BOWIE LOTS TCP II OVERVIEW									
SHEET	# LOTS IN THE R-R ZONE	# PARCELS IN THE R-R ZONE	# LOTS IN THE R-55 ZONE	R-R AREA (AC.)	R-55 AREA (AC.)	OWNERSHIP	# LOT SITED	100 YR. FP.	
1	27		5	5.94	0.92	OWNED	3		
2				7.37		OWNED	28		
3			53		4.25	OWNED	6	0.4	
4		3	15	4.92	0.88	NOT OWNED	0		
5	23			3.21		OWNED	12	0.65	
6	0			0.33		OWNED	0		
TOTAL	77	3	73	21.77	6.03	OWNED	73	1.05

Prince George's County Planning Department, M-NCPPC				
Environmental Planning Section				
TREE CONSERVATION PLAN APPROVAL				
TCP2-170-04				
	Approved by	Date	DRD #	Reason for Revision
00	LORI SHIRLEY	2/3/04		
01	*LORI SHIRLEY	10/04/05		
02	K.S.	04/12/10		
03	KIM FINCH	01/28/15		
04	KIM FINCH	10/14/2021		
05	Kim Finch	3/30/2024	NA	Block 26, Lot 62-70, 57-60
06				
Woodlands preserved, planted or regenerated in fulfillment of woodland conservation requirements on-site have been placed in woodland and wildlife habitat conservation easement recorded in Prince George's County Land Records at Liber ___, Folio ___. Revisions to this TCP2 may require a revision to the recorded easement.

BOWIE LOTS
HUNTINGTON CITY
BOWIE (4th) ELECTION DISTRICT
PRINCE GEORGE'S COUNTY, MARYLAND

COVER SHEET
TCP II

01/07/10 REV. TO SHOW RE-SUB. OF LOTS 27-38 & 52-56 BLOCK 26.	02/04/10 REV. TO PER COUNTY COMM. MP.	09/01/22 REVISED LOD FOR LOTS62-67 RC.	02/23/23 REVISED FOR LOT 62-67 RC.
DATE: APRIL, 2010	DWN. MWP	CHECKED GB	
SCALE: 1" = 30'			
PROJECT/FILE NO. 01012			
SHEET NO. 3 OF 5

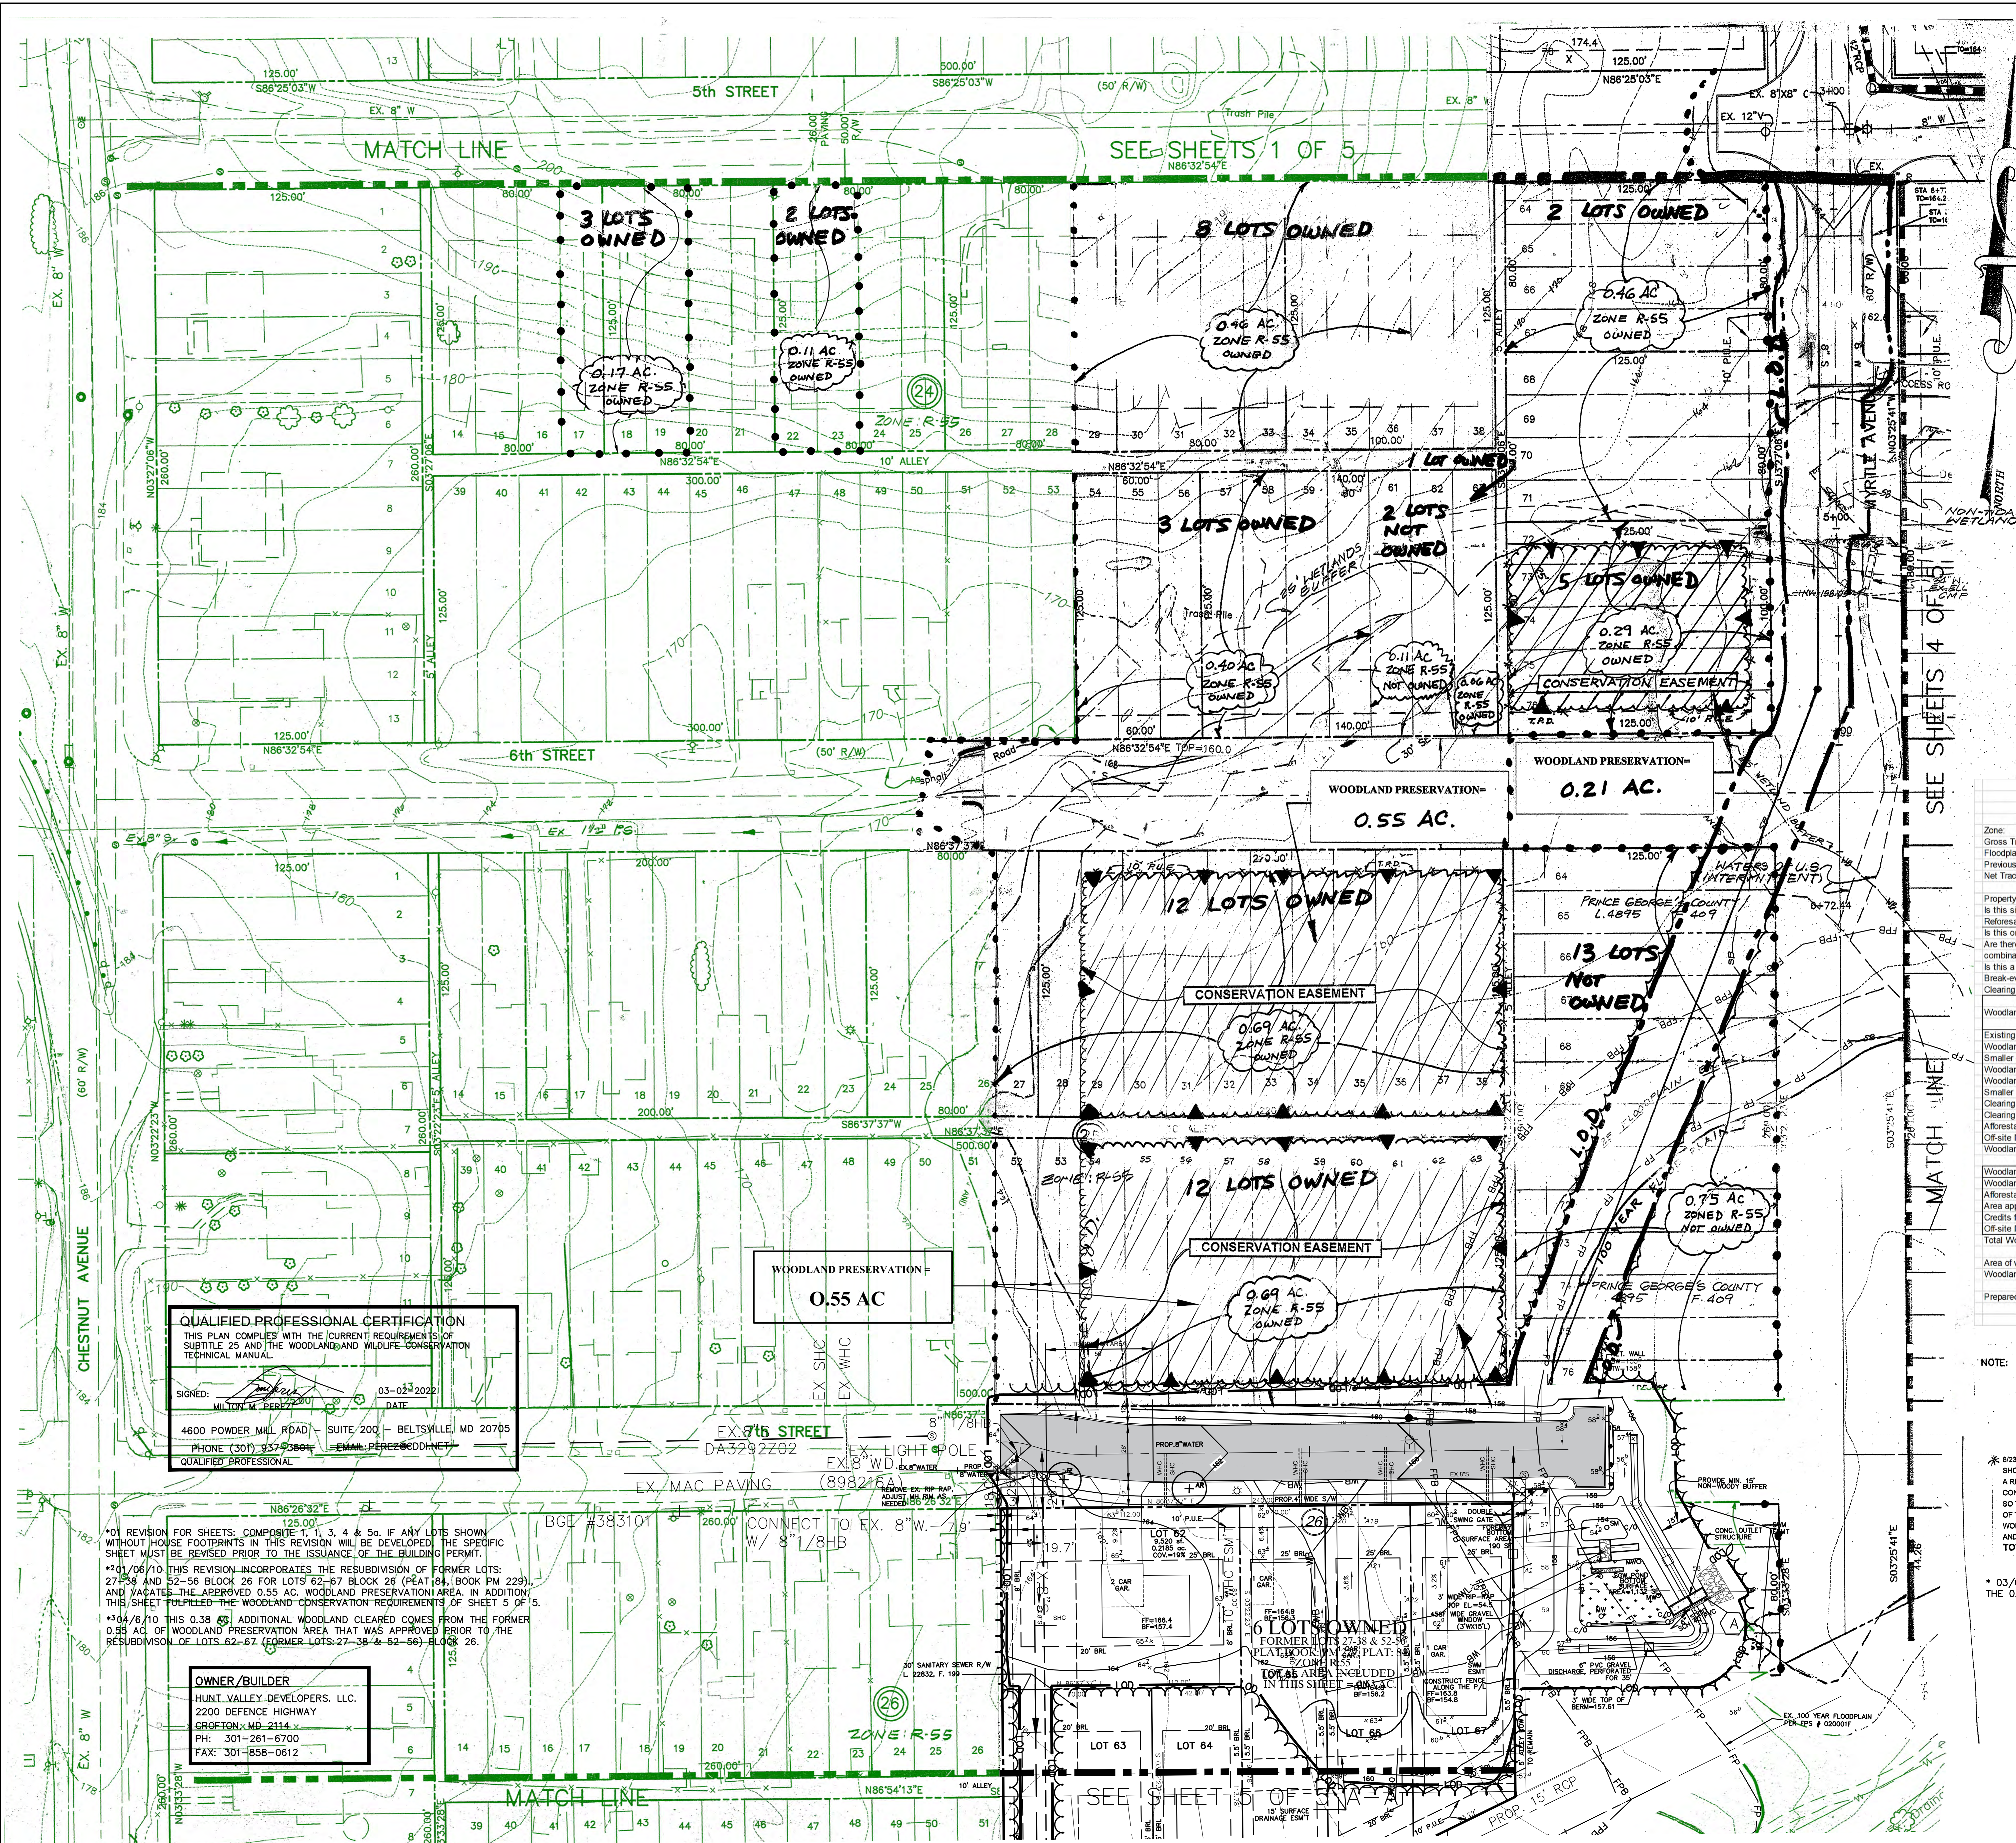
* 8/23/05 THIS SHEET WAS REVISED TO REMOVE 4 SITED LOTS SHOWN ON THE PREVIOUSLY APPROVED PLAN DATED 2/20/04. A REVISION TO THE SEWER LAYOUT WAS ALSO DONE. THIS CONSISTED OF ADDING 13 SINGLE LOTS, NOT OWNED (P.G. CITY, L. 4895 F. 409) SO THAT THE NEW SEWER CONNECTION COULD BE MADE. THE TOTAL AREA OF THESE LOTS (0.75 AC) WAS ADDED TO THE GROSS TRACT AREA OF THE WORKSHEET. 0.25 AC OF THE 0.75 TOTAL OF THESE LOTS IS EXISTING FLOODPLAIN AND HAS BEEN ADDED TO THE FLOODPLAIN COLUMN. TOTAL NUMBER OF LOTS REVISED FOR 8-23-05 REVISION=25

* 03/02/2023 REVISED LIMITS OF DISTURBANCE FOR LOTS 62-67 BLK. 26. THE 0.07 AC. WOODLAND PRESERVATION AREA ON LOT 57-60 WAS ELIMINATED.

SHEET NO.
5 OF 5

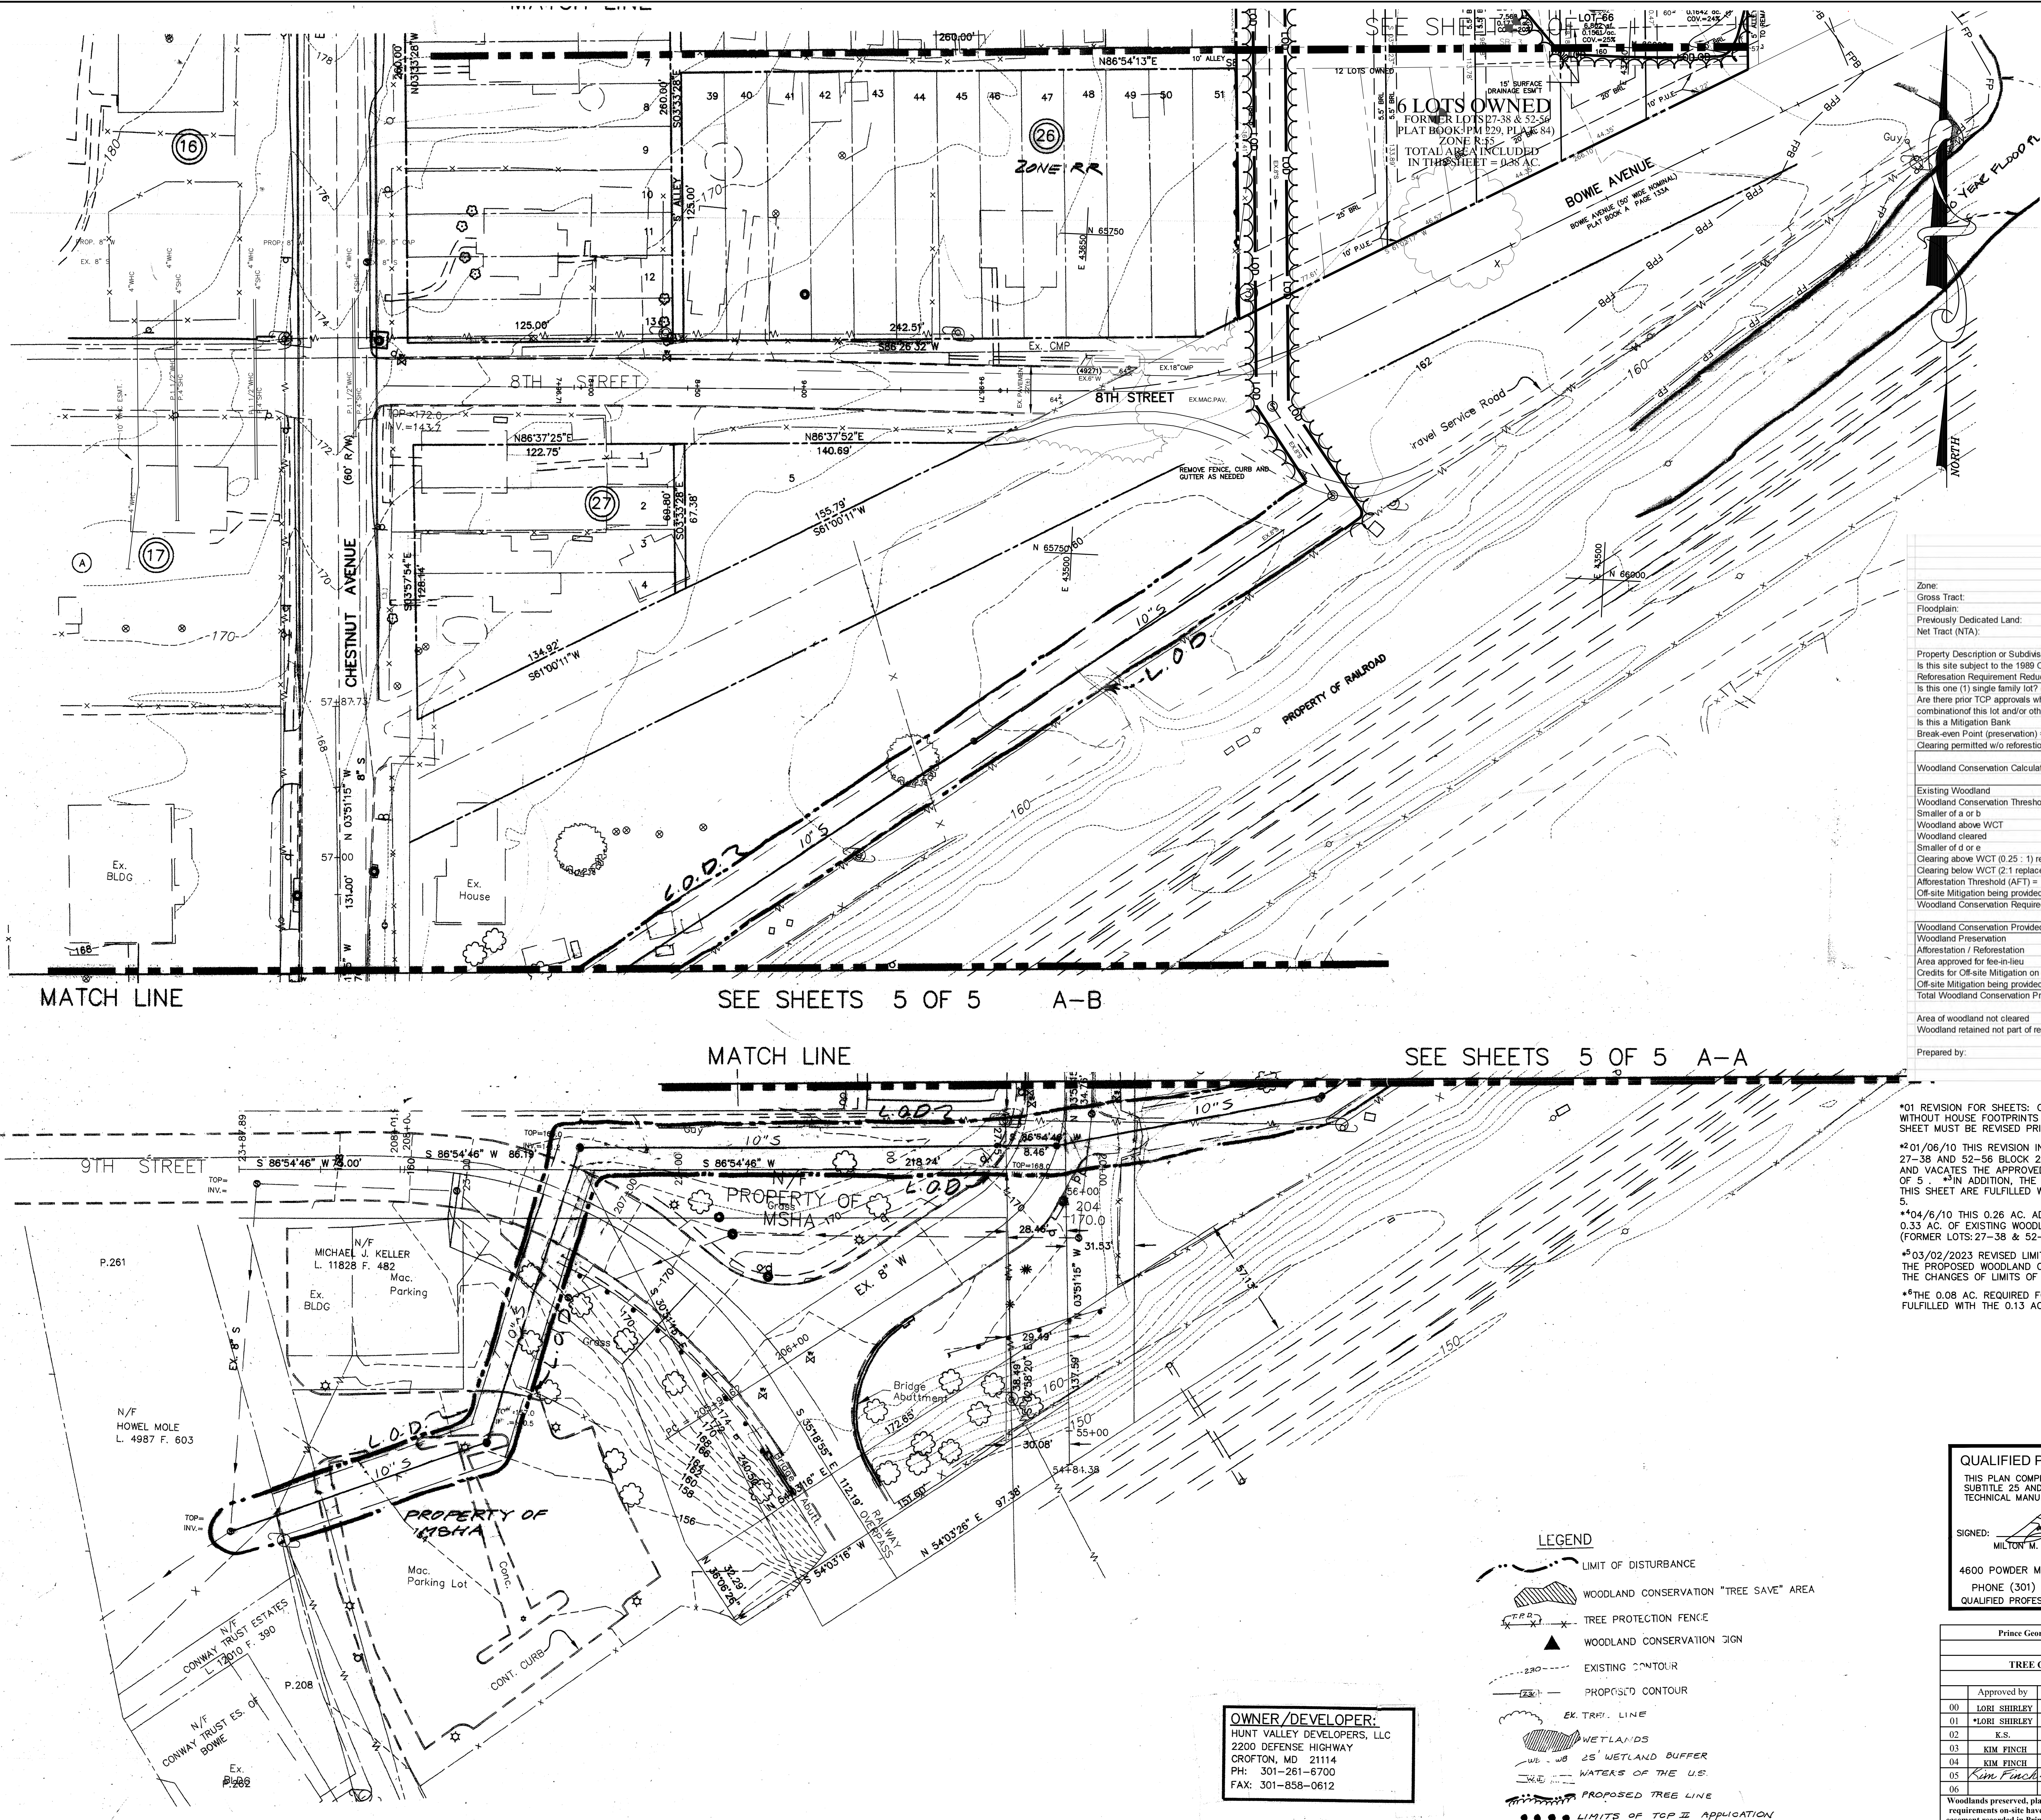
- *01/06/10 THIS REVISION INCORPORATES THE RESUBDIVISION OF FORMER LOTS: 27-38 AND 52-56 BLOCK 26 FOR LOTS 62-67 BLOCK 26 (PLAT 84, BOOK PM 229), AND VACATES THE APPROVED 0.45 AC. WOODLAND PRESERVATION AREA ON SHEET 3 OF 5. *IN ADDITION, THE 0.20 AC. REQUIRED FOR WOODLAND CONSERVATION ON THIS SHEET ARE FULFILLED WITH THE 0.23 AC. CONSERVATION EXCESS ON SHEET 3 OF 5.

- *04/6/10 THIS 0.26 AC. ADDITIONAL WOODLAND CLEARED COMES FROM THE FORMER 0.33 AC. OF EXISTING WOODLAND AREA PRIOR TO THE RESUBDIVISION OF LOTS 62-67 (FORMER LOTS: 27-38 & 52-56) BLOCK 26.

- *03/02/2023 REVISED LIMITS OF DISTURBANCE FOR LOTS 62-67 BLK. 26. THE PROPOSED WOODLAND CLEARED WILL DECREASE TO 0.05 AC. DUE TO THE CHANGES OF LIMITS OF DISTURBANCE.

- *THE 0.08 AC. REQUIRED FOR WOODLAND CONSERVATION ON THIS SHEET ARE FULFILLED WITH THE 0.13 AC. CONSERVATION EXCESS ON SHEET 3 OF 5.
